From: <Raymond_A_West@dom.com>
To: <wen@nrc.gov>
Date: 10/1/04 2:54PM
Subject: Comment Letter on Code Case N-323-1 re: [DG-1126] and [10CFR50.55a(b)(2)(xxi)(C)]

**Comment On The Acceptability Of ASME Code Case N-323-1 and
Corresponding Requirements In ASME Code Section XI, 1997
Addenda, re: [DG-1126] and 10CFR50.55a(b)(2)(xxi)(C)**

The attached background information to this letter provides support for my comment below concerning the removal of the unacceptable status of Attachment (1) ASME Code Case N-323-1, "*Alternative Examination for Welded Attachments to Pressure Vessels, Section XI, Division 1,*" listed in Draft Regulatory Guide DG-1126, (Proposed Revision 1 to Regulatory Guide 1.193), ASME Code Cases Not Approved For Use.

FIG. 1 WELDED ATTACHMENT

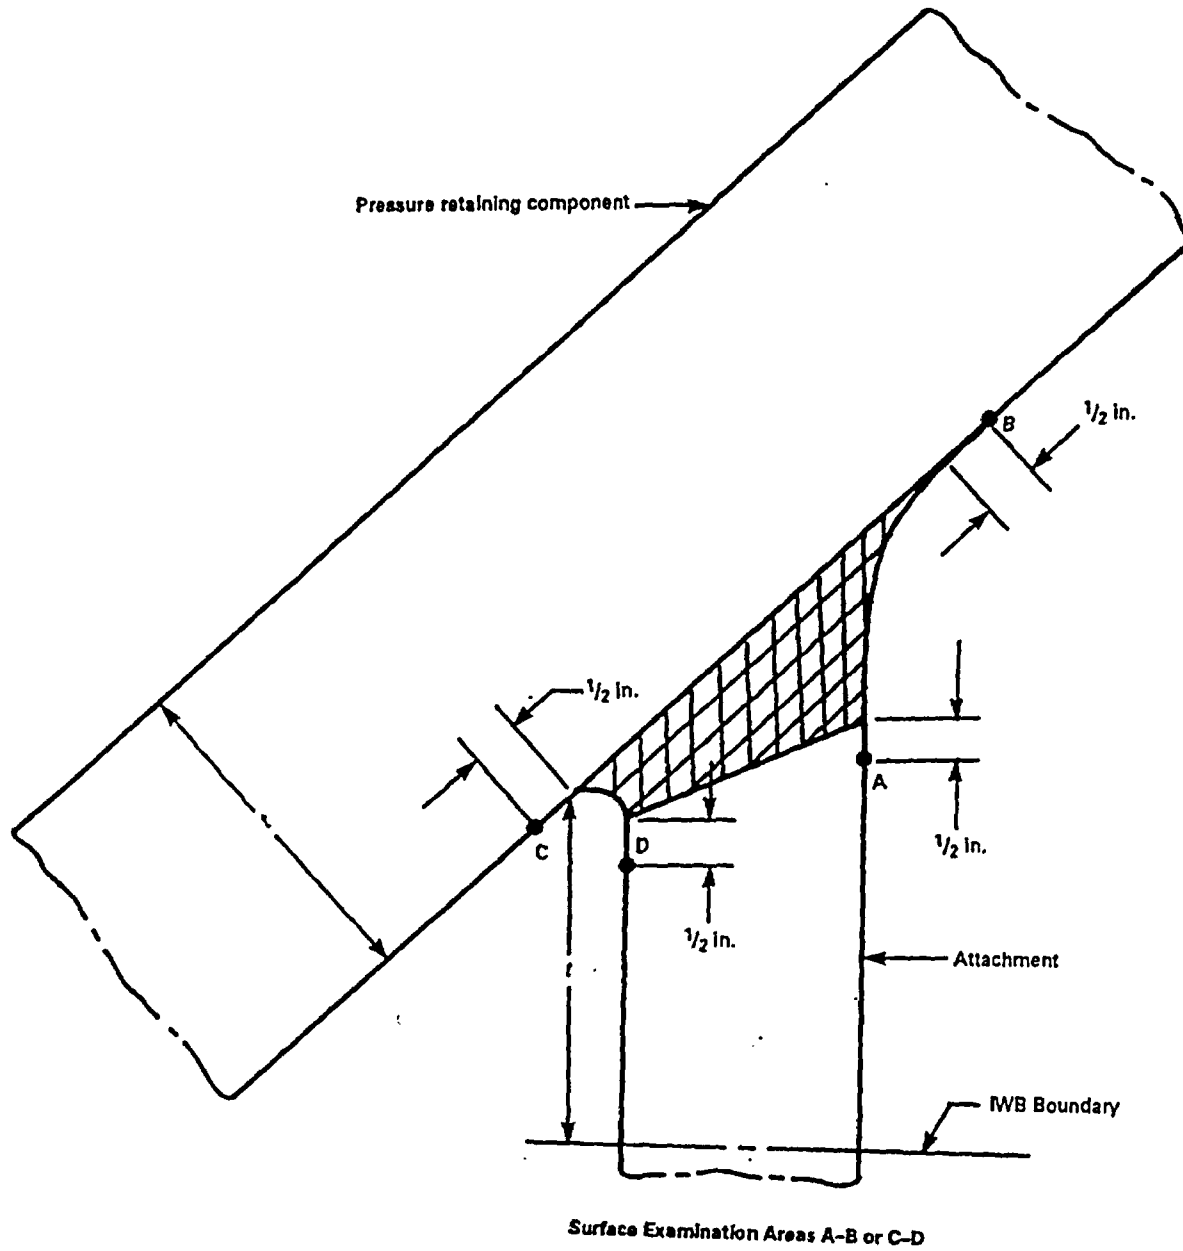
Still no examination figures existed and it is believed that the weld design for which these requirements was centered on was based on that design depicted in Figure 1 of Code Case N-323-1. It still seemed clear that the pressure boundary integrity of the vessel was the reason that this examination was being performed. Additionally, this was the time frame that the 1976 Addendas were published and not approved by the NRC. One of the main reasons for the disapproval of these Addendas was that the NRC wanted all pressure boundary welds to be examined for 100% of their weld length or circumference. At the time, the NRC believed that this increase would have no significant impact on the industry because all these welds would eventually be examined using automated techniques and so Section XI, succumbed to the NRC, and accepted the 100% requirement. Regardless of whether this decision was right or wrong, vessel-welded attachments were now included as part of this 100% requirement and they are still predominantly being examined with manual techniques today.

- For the weld design depicted in Figure 1 of Code Case N-323-1, where the weld is directly attached to the vessel wall, the only location expected for a crack to occur could be on the outside surface of the support skirt weld, in the weld heat affected zone, because the inside surface is in compression. So when examining the outside of the weld, the worst case for this type of weld would be for a crack to occur on the vessel side of the weld, because it could threaten the vessel's pressure boundary integrity. With this being the case, one would expect that a surface examination in this area would be sufficient to detect this type of a crack. This is the type of NDE prescribed for this weld in Code Case N-323-1 and the 1997 Addenda and later Editions and Addenda of ASME Section XI, and also has been required in several past versions of the Code.

FIG. 2 WELDED ATTACHMENT

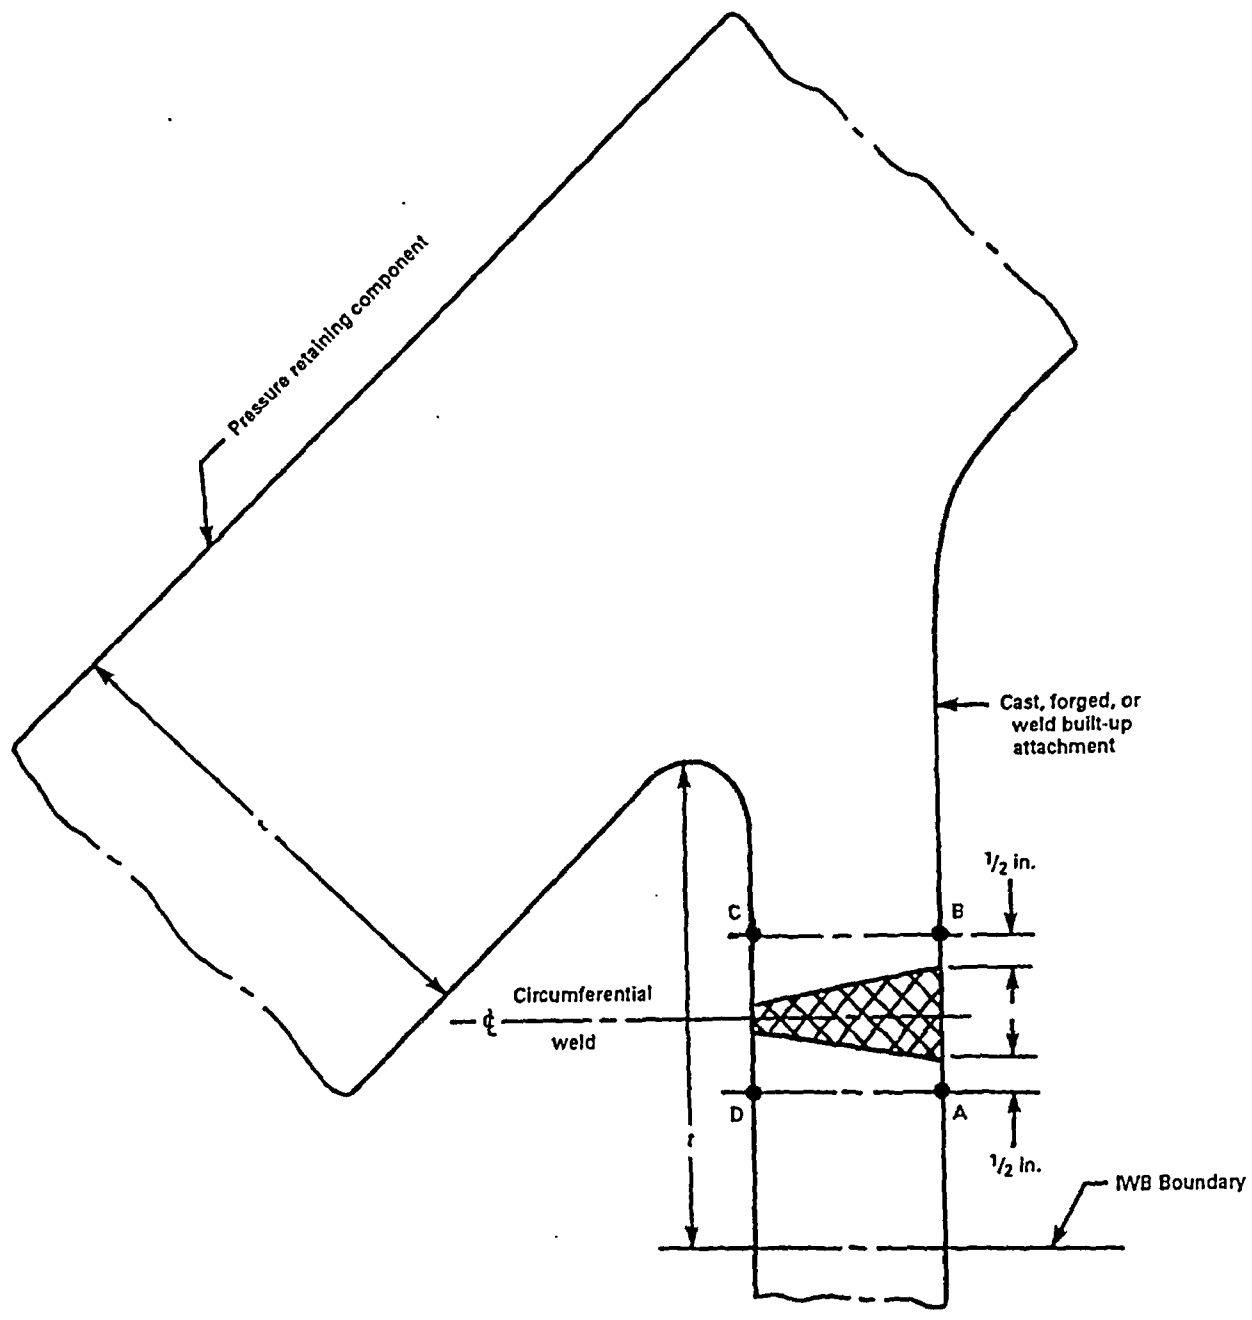
No examination figures existed at this time and it was clear that the inclusion of the base metal beneath the weld was to look for flaws in the vessel from this weld that could affect the pressure boundary integrity of the vessel. The weld design that these requirements seemed to be centered on is the same as that depicted in Figure 1 of Code Case N-323-1, because the pressure boundary integrity of the vessel would not be affected by the failure of the weld in Figure 2.

- Next, for the weld design depicted in Figure 2 of Code Case N-323-1, the same type of crack could occur and it would also be on the outside surface of the support because the inside is again in compression. However, the affect of a crack in this weld would not result in a loss of pressure boundary integrity because it would not affect the vessel directly, and therefore, it is not as critical as the design depicted in Figure 1. If a crack does occur in this weld, it could be completely through the support skirt wall in localized areas, but nothing would happen to affect the function of the support skirt from holding up the vessel. Because of this situation, it should not be a requirement to volumetrically examine this weld just because it is considered to be practical by the opinion of the NRC Staff. Either a surface examination or a volumetric examination from the accessible side of this weld would be adequate to determine the level of degradation that would need to be identified for its unacceptability.
